Imray Correction Notice

ICC52-2

Chart C52 WGS 84

Edition 2015

Block correction for C52
ILNW 183/16

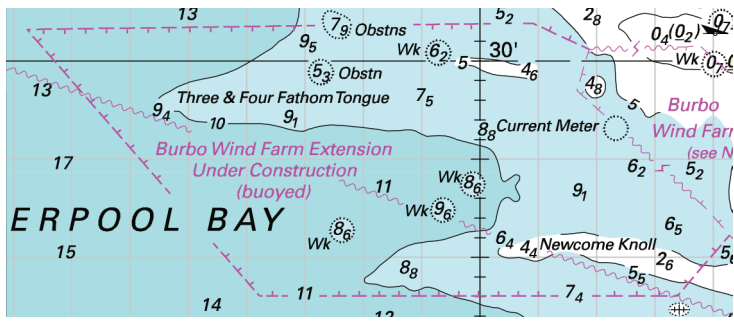
4 Liverpool Bay, Burbo Wind Farm

Insert accompanying block correction centred on 53°28'·97N 3°16'·89W. (ILNW 183/16)

Block correction for C52 (Plan G)
ILNW 418/16

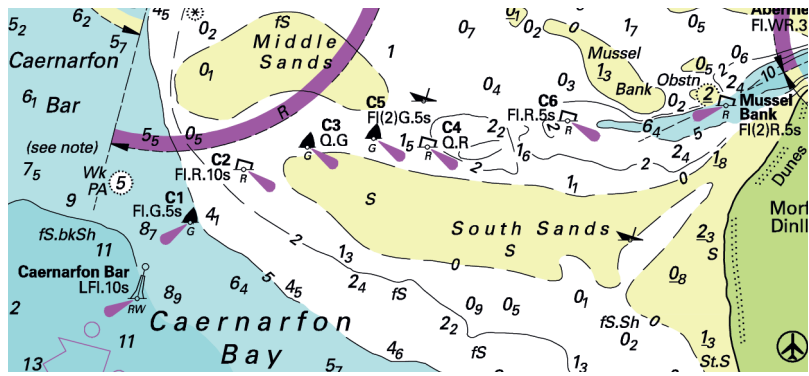
8 Caernarfon Bar (Plan G)

Insert accompanying block correction centred on 56°06'·92N 4°23'·08W (ILNW 418/16)
